Access Compliance Report

Public Rights-of-Way

Intersection ID: 11707	Main Street: N_GRAHAM_ST	Cross Street: W_6TH_ST	Location: NE
ADA ID: AFB31AE49931	Ramp Type: Perp	Initial Pass/Fail: Pass	Overall Compliance: No
Severity Score: 0.25			
Codes/Mitigation Info/Possible Solution		Field Measurements/Component Compliance

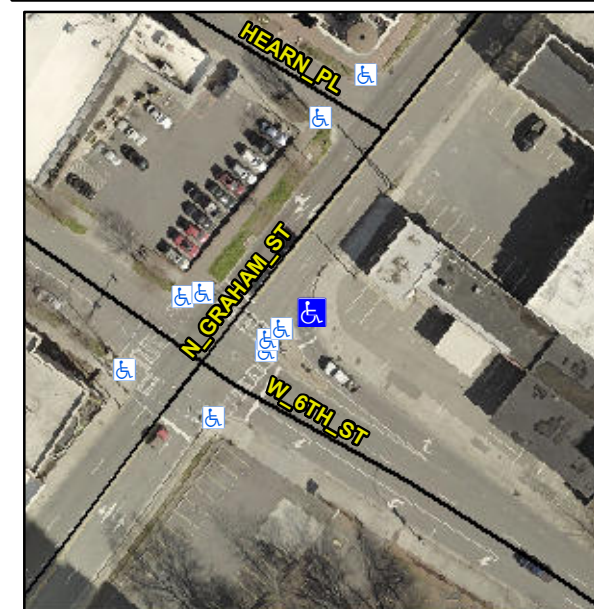
Not Found, R304.2.2-Perp, R304.3.2-Para

Compliance	Description	Data	Compliance	Description	Data
N/A	Ramp Length (in)	59.0	Yes	Ramp Slope (%)	8.0
Yes	Ramp Width (in)	48.0	Yes	Ramp XSlope (%)	3.1
N/A	Flare Type LT	Sloped	N/A	Flare Type RT	N/A
N/A	Flare Slope LT (%)	5.9	Yes	Flare Slope RT (%)	6.1
N/A	Flare Traversable LT?	Yes	N/A	Flare Traversable RT?	Yes
Yes	Landing Length (in)	81.0	Yes	DWS Provided?	Yes
Yes	Landing Width (in)	48.0	Yes	DWS Contrast?	Yes
No	Landing Slope (%)	2.7	Yes	DWS Length (in)	24.0
Yes	Landing X Slope (%)	2.4	Yes	DWS Full Width?	Yes
N/A	Landing Curb? (Y/N)	No	Yes	DWS Offset (in)	0.0
N/A	Shared Landing?	No			
Yes	Gutter Ponding?	No	Yes	Gutter Slope (%)	2.4
Yes	Gutter Lip Ht (in)	0.0	Yes	Gutter X Slope (%)	2.9
N/A	Painted X Walk1?	Yes	N/A	Painted X Walk2?	N/A
	X Walk 1 Direction	To W		X Walk 2 Direction	N/A
N/A	X Walk 1 Width (in)	148.0	N/A	X Walk 2 Width (in)	N/A
	X Walk 1 Slope (%)	9.4		X Walk 2 Slope (%)	N/A
	X Walk 1 X Slope (%)	4.4		X Walk 2 X Slope (%)	N/A

Remove & Replace Entire Ramp.
